Nielsen Architects

Staged demolition of all existing buildings and the staged construction of a new ALDI supermarket and Chemist Warehouse building with shared car parking for up to 120 cars, signage, fencing and landscaping.

DA 100/E074/18

ASSESSMENT REPORT

Figure 10: Suggested 'Keep Clear' Traffic Management Measure.

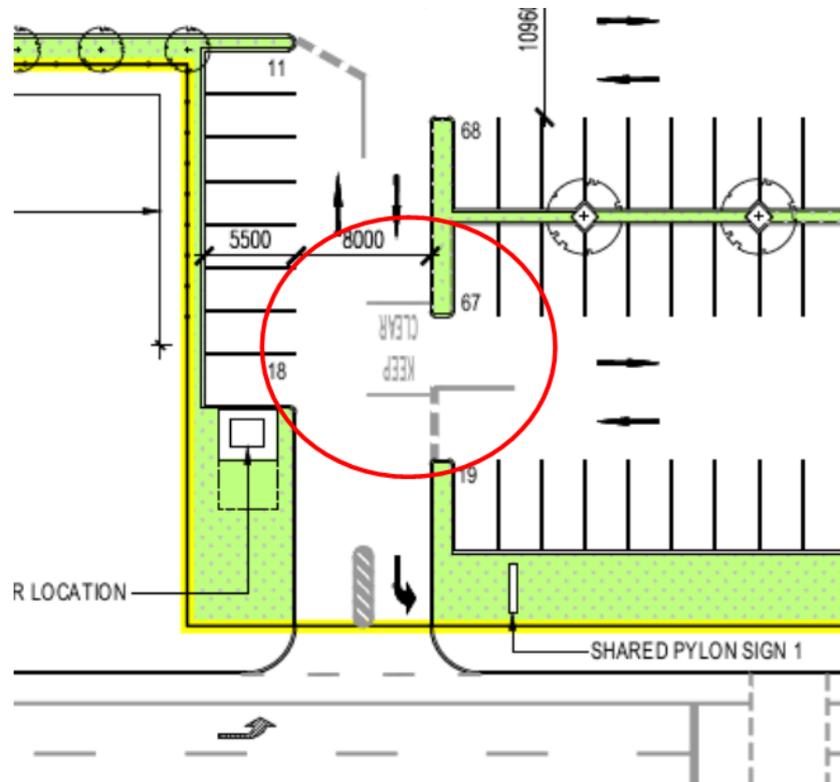
GTA Consultants suggest the addition of a 'Keep Clear' marking at the aisle intersection as shown in Figure 10 would assist in managing this issue.

It is considered that driver behaviour would see most vehicles driven further west into the car park in order to find a car park as close as possible to the new retail buildings.

PROPOSED SITE PLAN
1:500

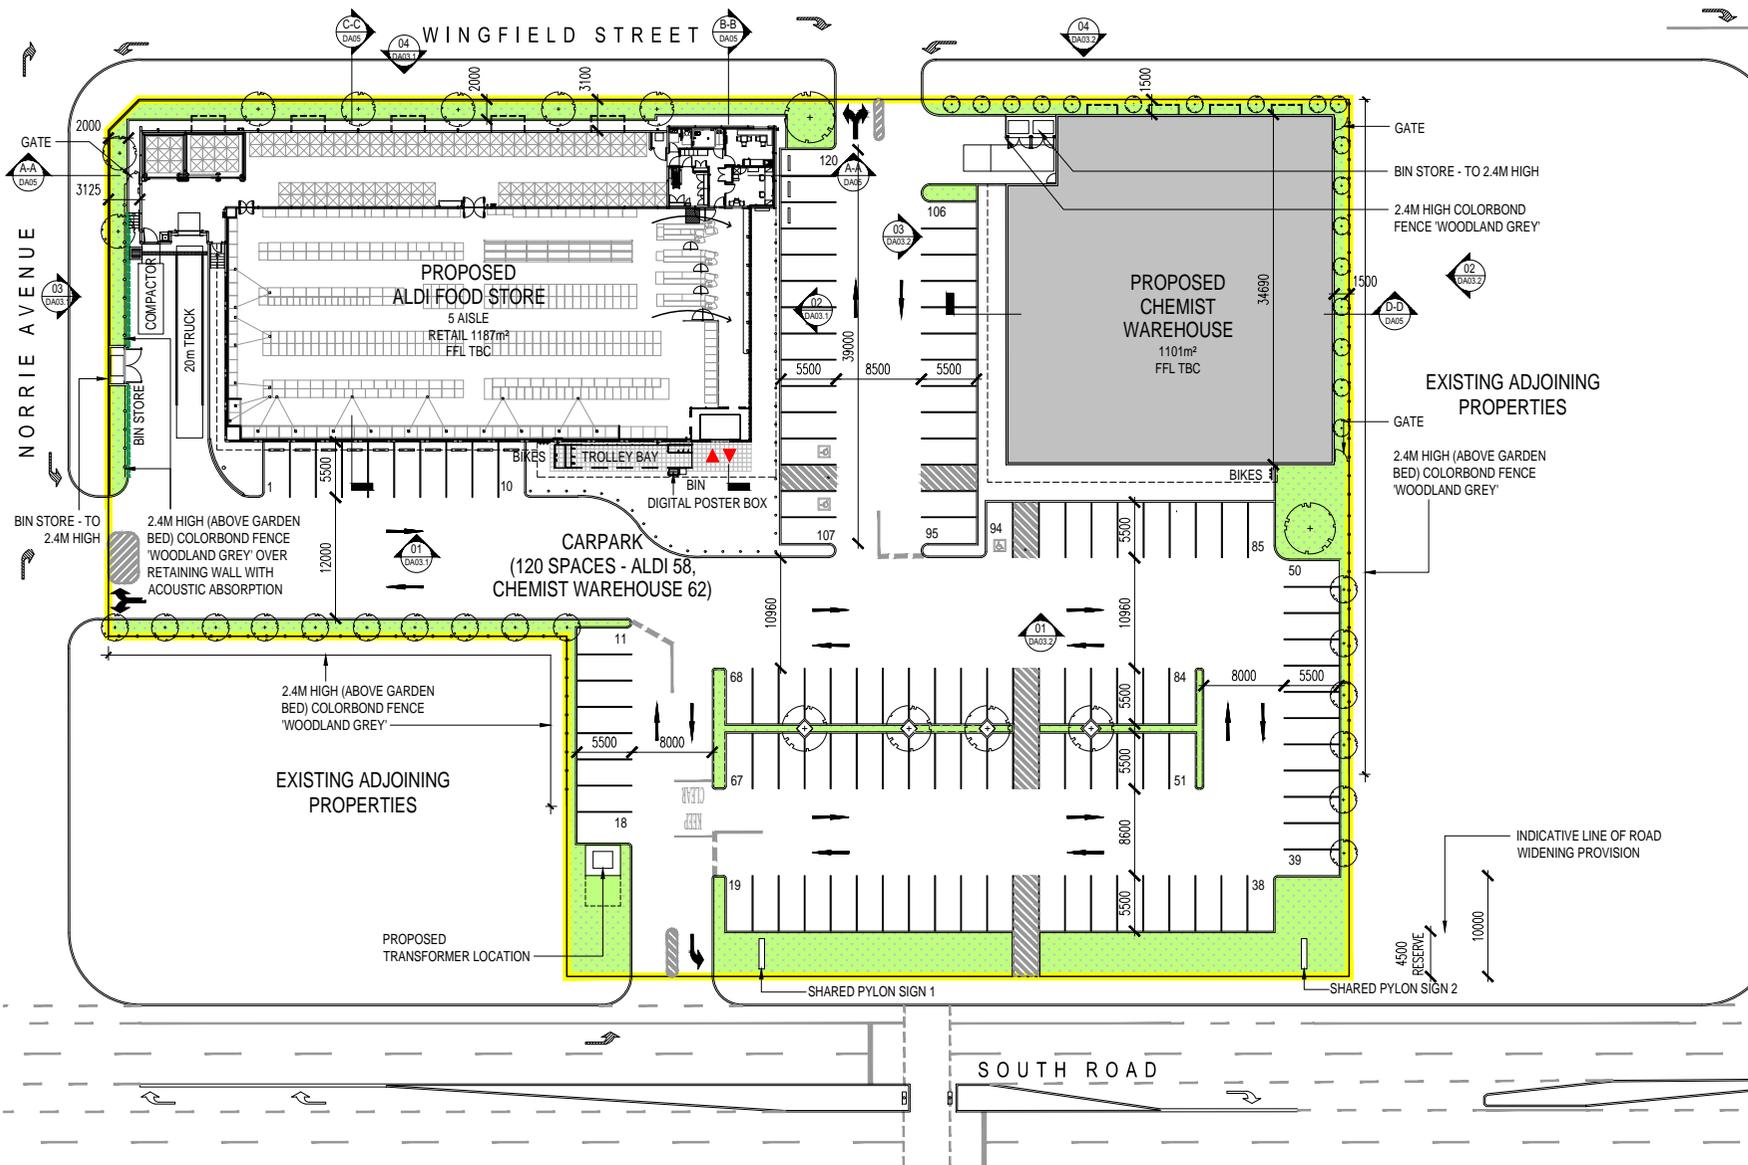
It is noted that the plans show some landscaping along the South Road frontage of the site and adjacent to the access points. Whilst DPTI does not object to this, clear sightlines as shown in Figure 3.3 'Minimum Sight Lines for Pedestrian Safety' in *AS/NZS 2890.1:2004*,

1. The access points shall be in general accordance with Nielsen Architects Proposed Site Plan, Project No. 2052, Drawing No. DA02.3, Rev. L dated 29 November 2018.

6. Clear sightlines, as shown in Figure 3.3 'Minimum Sight Lines for Pedestrian Safety' in *AS/NZS 2890.1:2004*, shall be provided at the property line to ensure adequate visibility between vehicles leaving the site and pedestrians on the adjacent footpath.

Figure 6.9 Site plan and recommended acoustic treatments (c/-Sonus image)

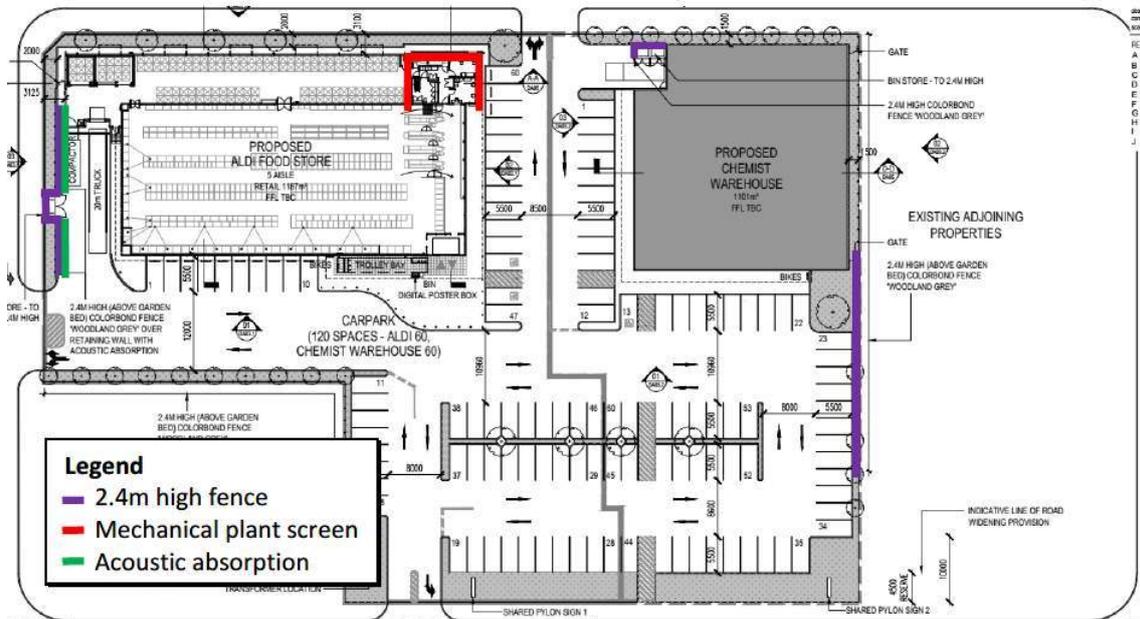
- Specific fence heights and constructions including installation of acoustic absorption:
 - » Construct 2.4m high “Colorbond” fences as shown in **PURPLE** (see **Figure 6.9**) such that they are sealed airtight at all junctions, including at the ground and at the building wall;

- » Install 50mm thick acoustic insulation with a minimum density of 32 kg/m³ to the ALDI loading area fence for the extent shown in **GREEN** (see **Figure 6.9**). The insulation should extend for the full practicable height of the fence and be should be installed as indicated within the Sonus report; and

- » Screening of ALDI mechanical plant for the extent shown in **RED** (see **Figure 6.9**).

Figure 1 Proposed 'Keep Clear' carpark marking

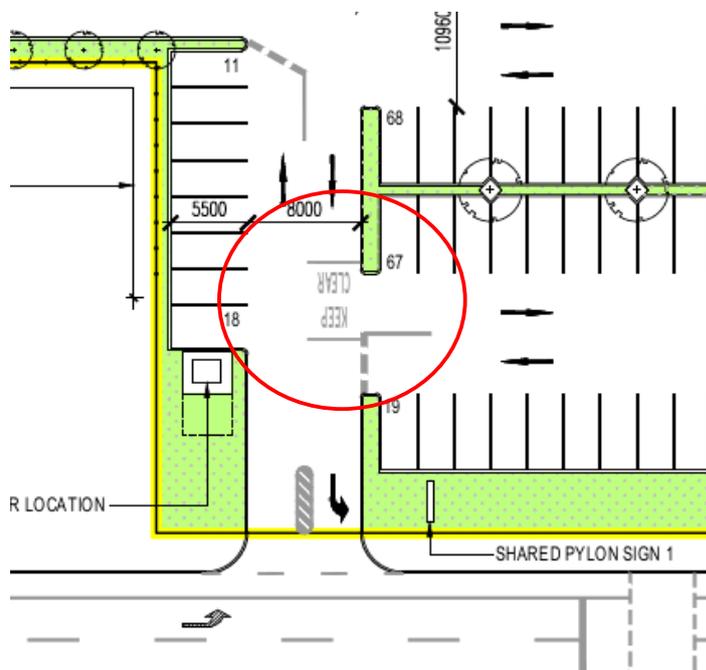
As stated, GTA have suggested an alternative solution, being the addition of a 'Keep Clear' bitumen marking at the aisle intersection (refer to extract below). The revised plans illustrating this addition are provided in **Appendix 1**.
